June 14, 1984

Docket No. 50-423

Millstone Nuclear Power Station, Unit No. 3
Additional Information for Question 492.6
and Draft SER Open Items CPB-3 and ICSB-14

FIGURE 4.4-10
 DISTRIBUTION OF INCORE
 INSTRUMENTATION
 MILLSTONE NUCLEAR POWER STATION
 UNIT 3
 FINAL SAFETY ANALYSIS REPORT

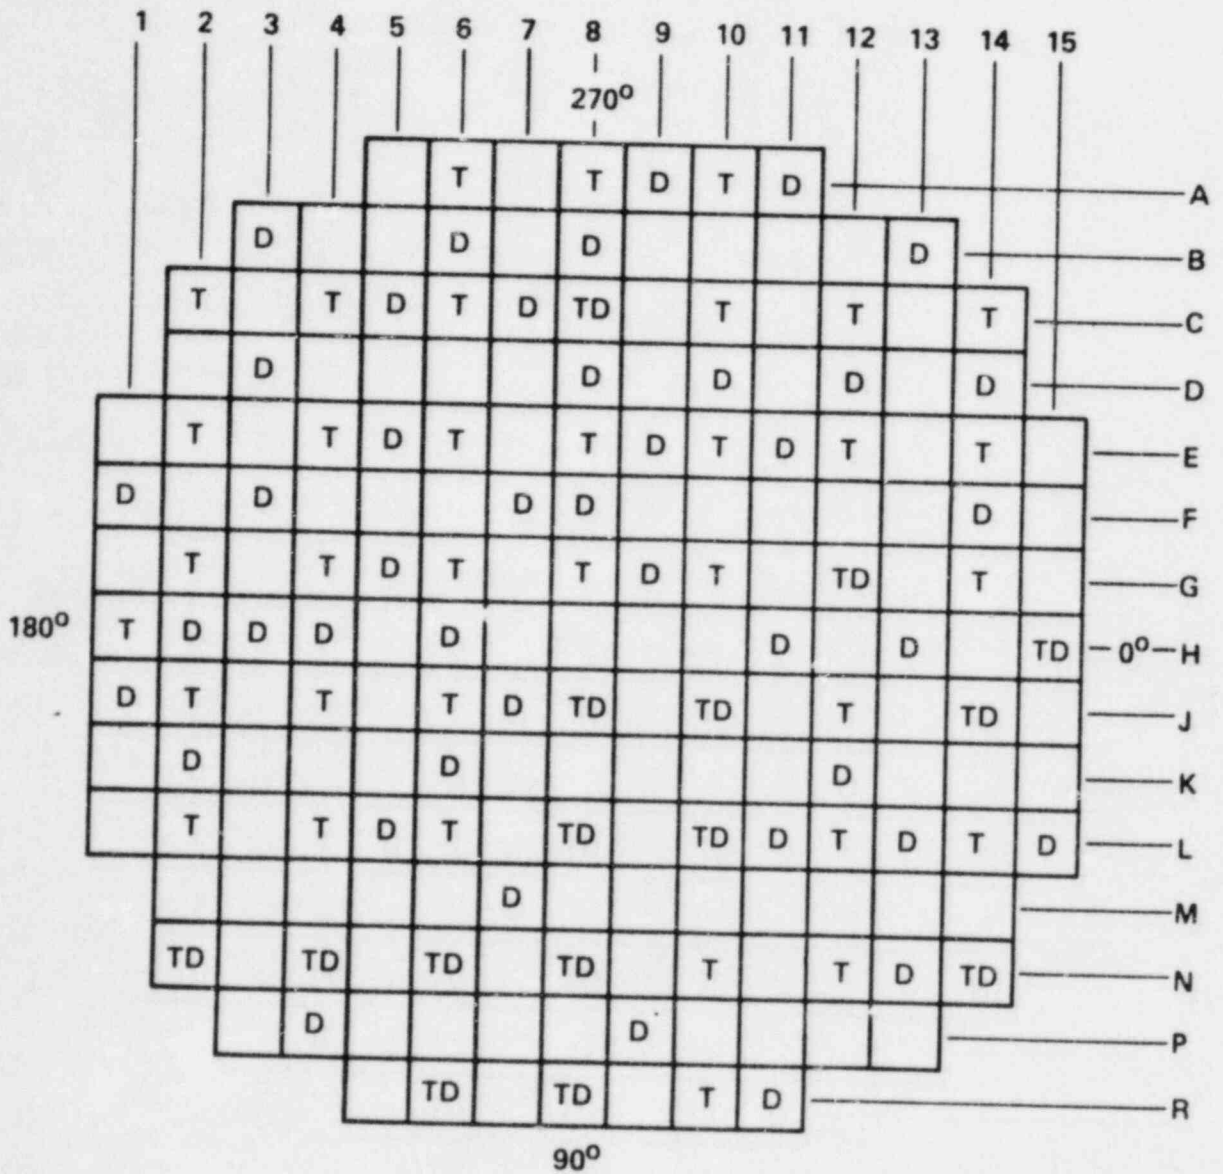
1. Provide diagram of core exit thermocouple locations or reference the generic description if appropriate.

Refer to FSAR Figure 4.4-10 (Attached)

T = THERMOCOUPLE (50 LOCATIONS)
 D = MOVABLE INCORE DETECTOR (58 LOCATIONS)
